80960Cx Processor

Specification Update

October 1998

Order Number: [272875-004](#)

Figure 1. Timings for Correct Operation

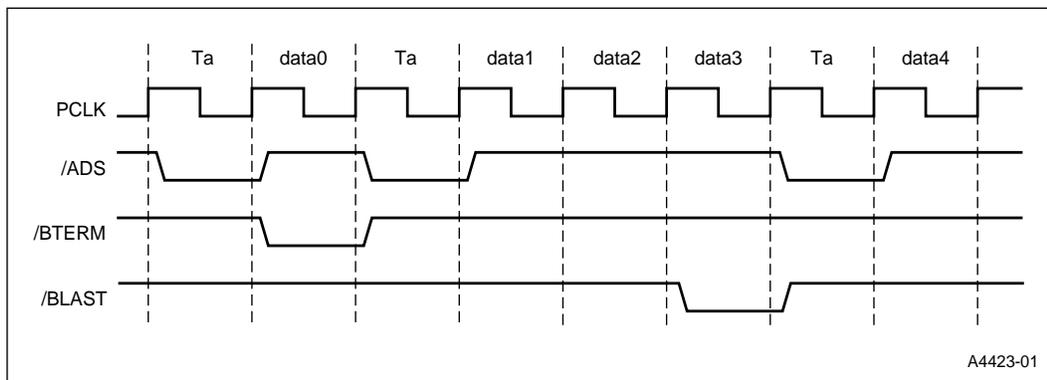
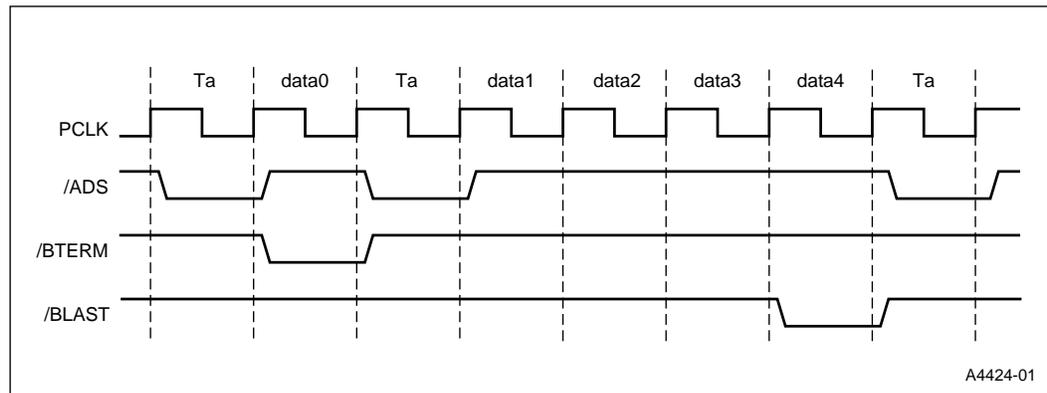
Correct Operation

If BTERM# is asserted during data(0), then ADS# will be asserted again for data(1) and the access will end by asserting BLAST# while reading data(3).

Incorrect Operation

The access spans over data3. For example, BLAST# is asserted while data4 is read.
